Building Permit Application

Permit No.: B14004173

B15002062_13112 Greenberry Road

From: Oswald, Hank
Sent: Thursday, December 04, 2014 11:10 AM
To: 'JIM@DECATURBUILDINGSERVICES.COM'
Subject: B14004173_13110 Greenberry Lane

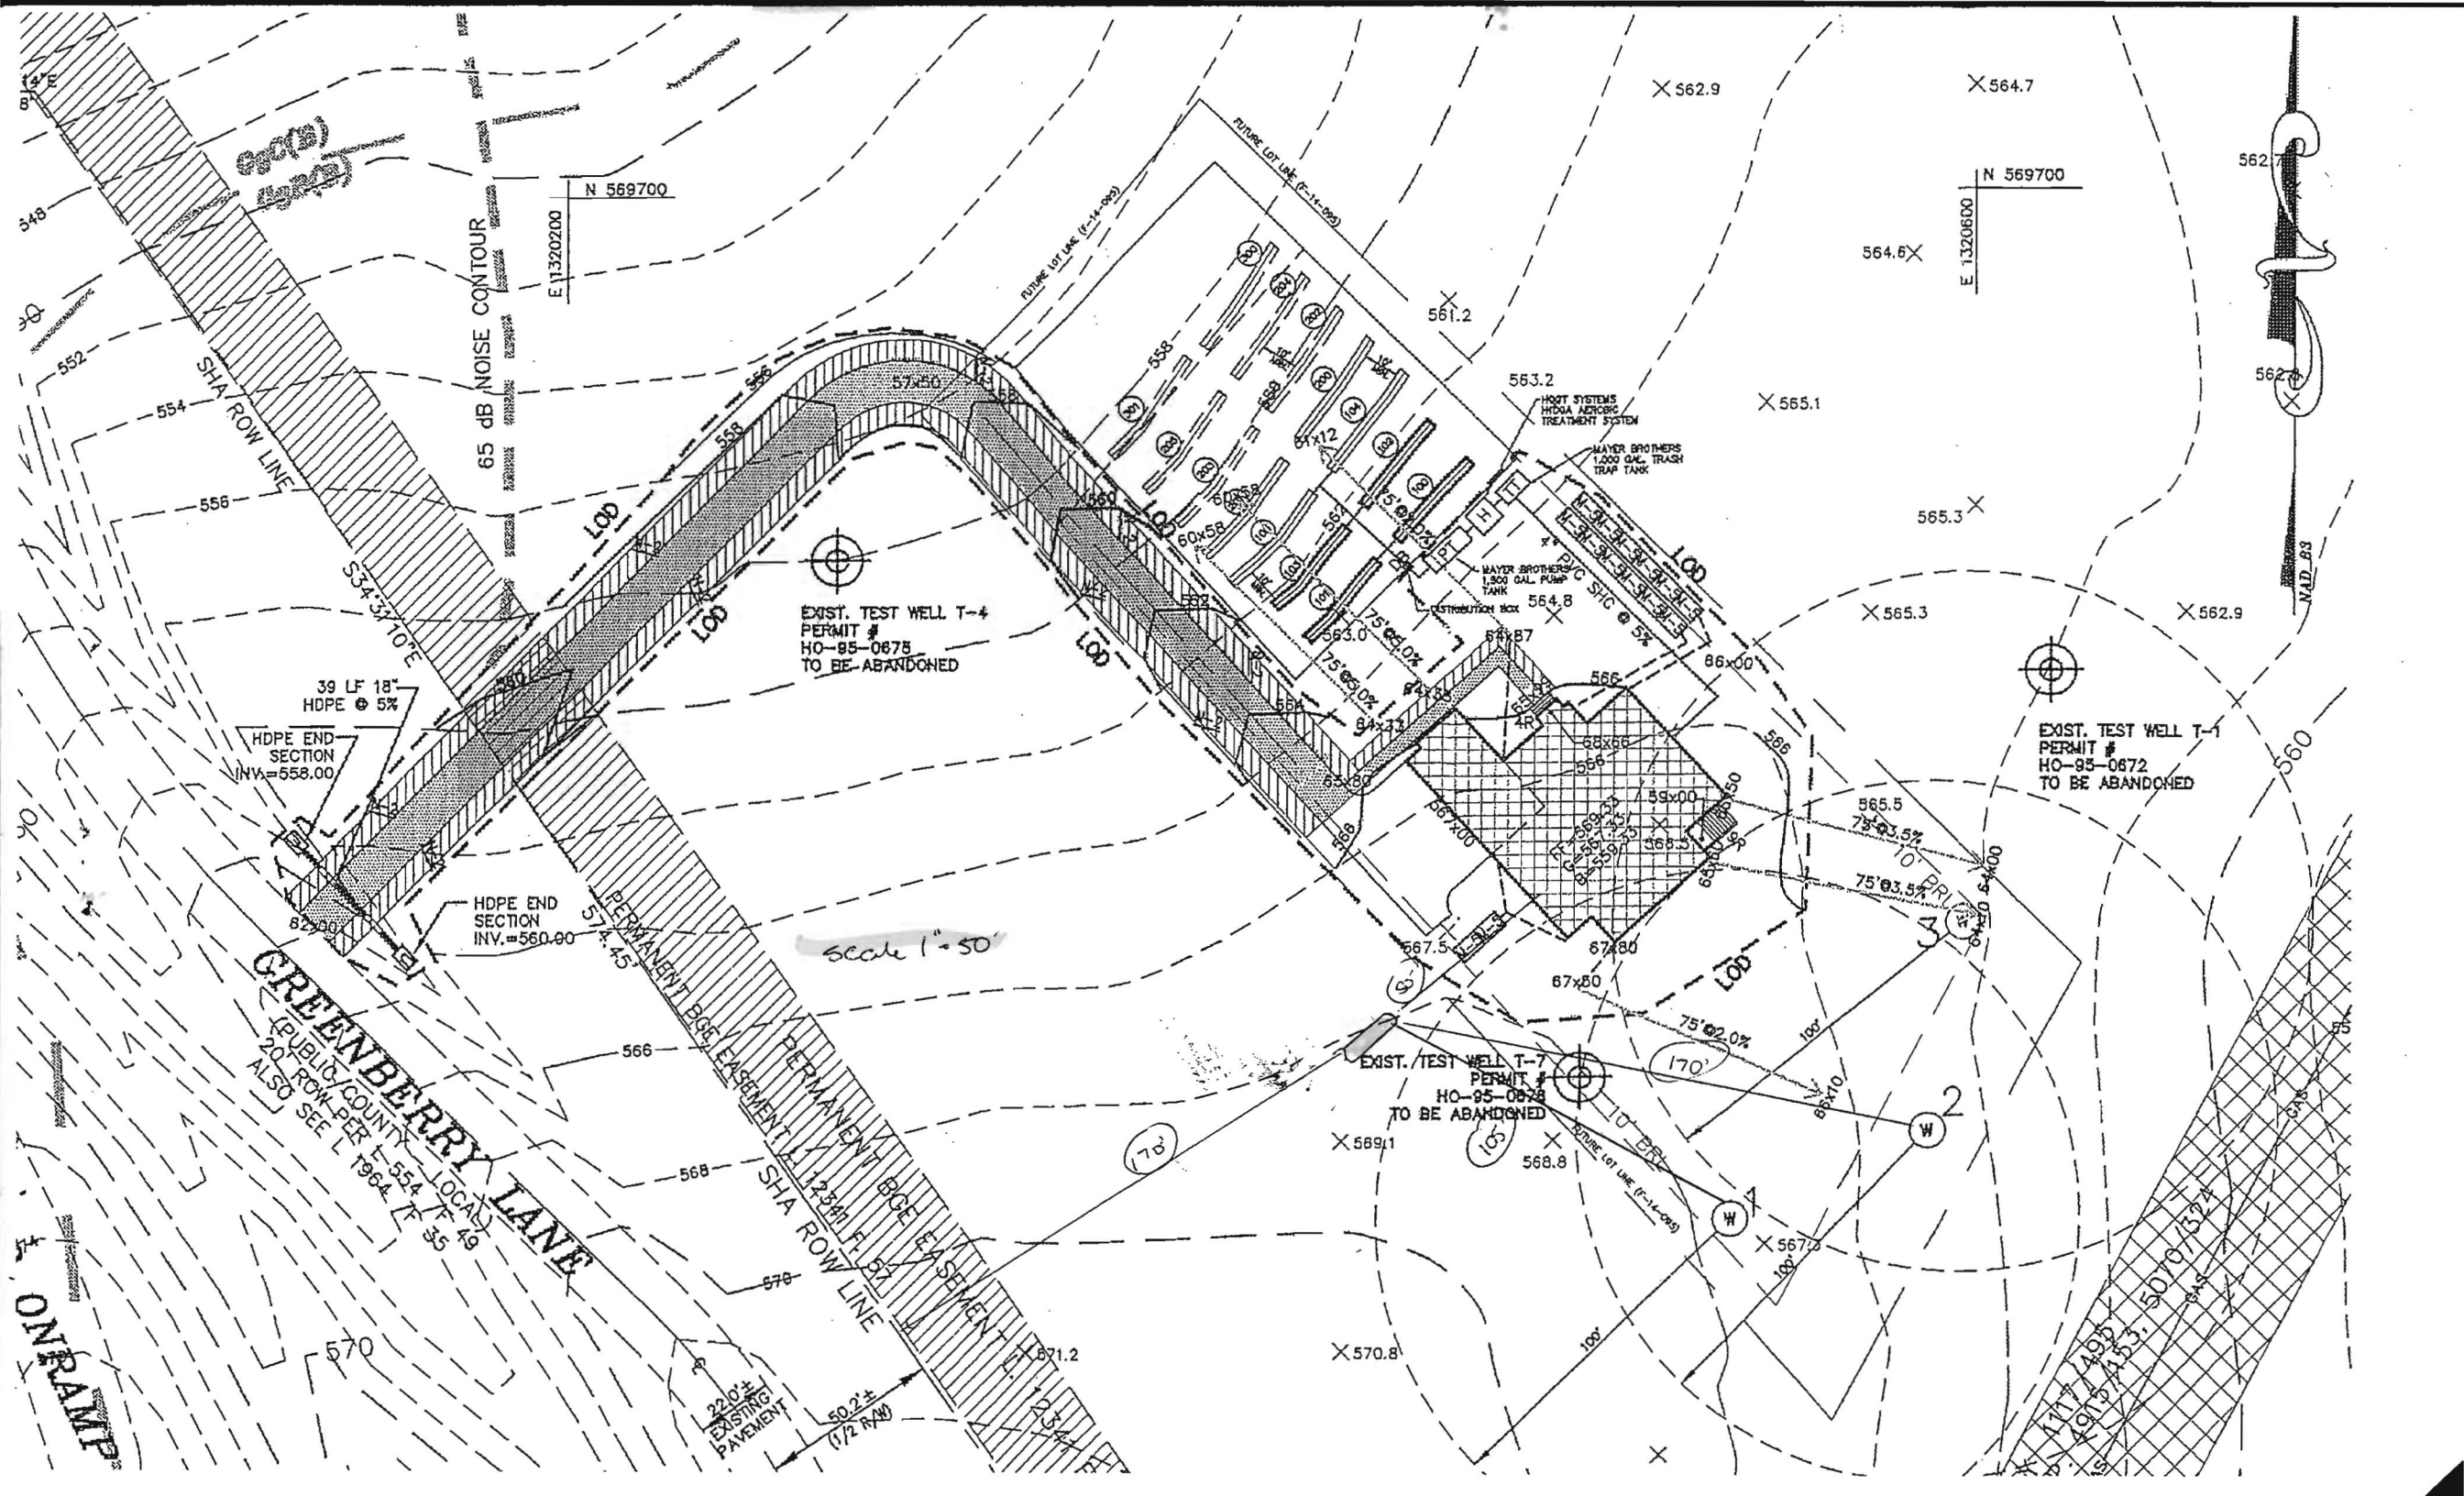
- Do you really want to place the propane tank for Lot 2 on lot 1? This will cause a delay in our office at time of subdivision review/approval.
